**Sidewalk Detour or Diversion (TA-28)
The City Church
4100 River Road NW**

Permit Details

Tracking Number: 157657
 Intake Date: 05/15/2016
 Assigned Date: 05/18/2016
 Assigned Technician: Catrina Felder
 Permit Type:
 Archived?: **N**
 Status: **Assigned**
 Work Location: [4100 RIVER ROAD NW, WASHINGTON, DC 20016](#) [View Map](#)
 Locked? **N**
 Effective Date: 06/06/2016
 Type Description: Fixture: Bollard(s) (Exception)
 Work Detail: Replace one Bollard and install an additions Bollard, totaling two Bollards
 Conditions:
 *All street trees located within the work zone shall have a 6' high chain link fence placed around the tree space to the extent of the box (min 4' x 9') or in a continuous planting space to the extent of the dripline. The fence shall be installed prior to work starting and removed after work has been completed.
 *All work must comply with all District regulations and statutes. Violation may result in revocation of this permit.
 *Extended restoration may be required. Level of restoration to be determined by DDOT. A DDOT Public Space Construction Inspector (202-645-7050) must authorize any restoration before work begins.

THE CITY CHURCH - 4100 RIVER RD NW, WA

Bollard Locations

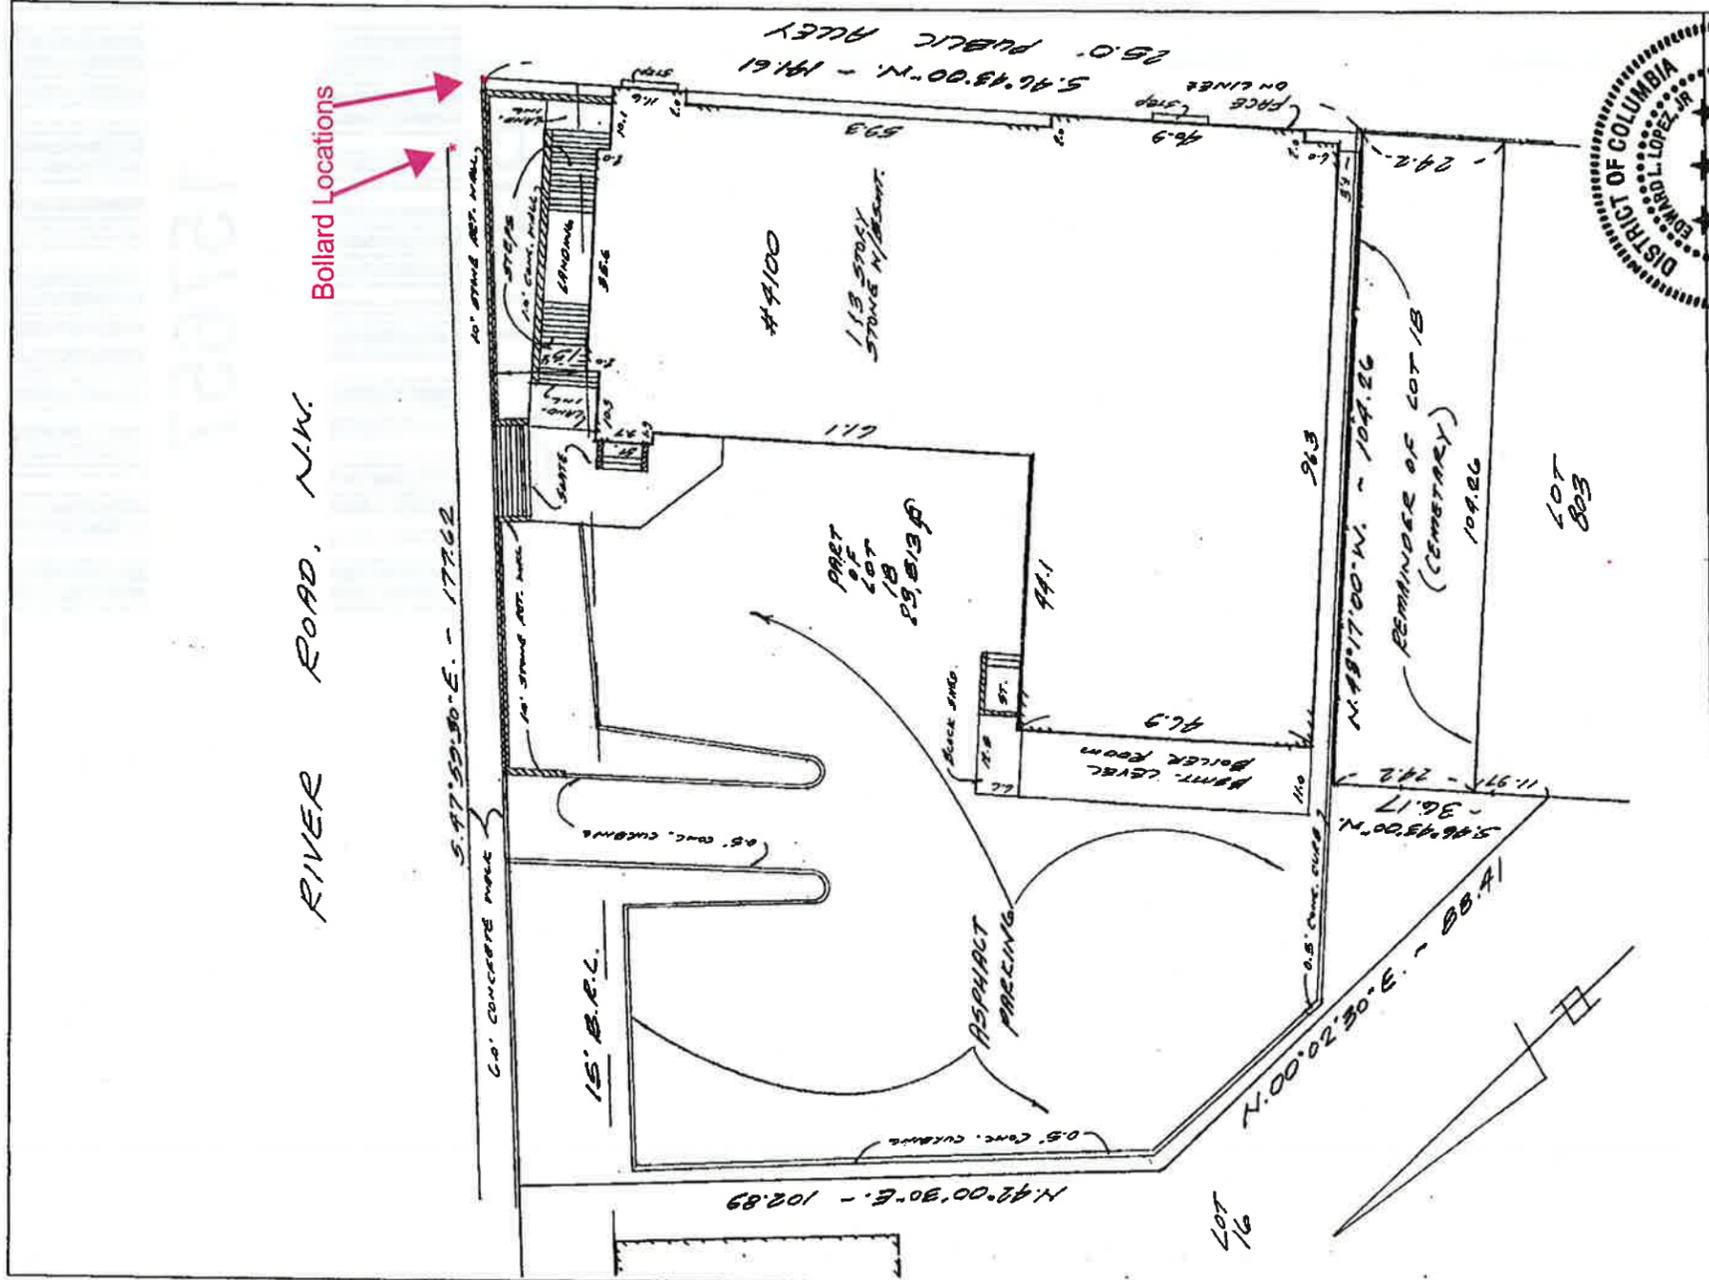
Agency	Sent Date	Return Date	Reviewer Name	Status	Util #	Notes
WMATA/JDAC	05/31/2016		LaShawn Bost	NO RESPONSE	61460	
VERIZON	05/31/2016	06/02/2016	Mary Polk	APPROVED	61461	
OP	05/31/2016	06/20/2016	Timothy Maher	REVISION NEEDED		Jun 20 2016 10:59AM tmaher wrote for Applicant - - OP can support the bollard installed at the rear of the sidewalk adjacent to the alley as a form of pedestrian protection. However, OP does not support the installation of a new bollard out by the established curbline of River Road.
UFA	05/31/2016	06/16/2016	Sharon Dendy	REVIEW NOT REQUIRED		Jun 16 2016 4:55PM sdendy wrote for Applicant - UFA defers to DDOT PPSA and the Office of Planning with regards to the bollard installation since there are no existing street trees and the mulched strip in front of the property is less than 4 feet and does not contain any other plant materials.
WASH GAS	05/31/2016	06/20/2016	Don Srisukwattananan	APPROVED WITH CONDITION	61462	Jun 20 2016 4:14PM dsrisukwattan wrote for Applicant - There is an active 4" gas main around the proposed bollard location. Call Miss Utility before digging.
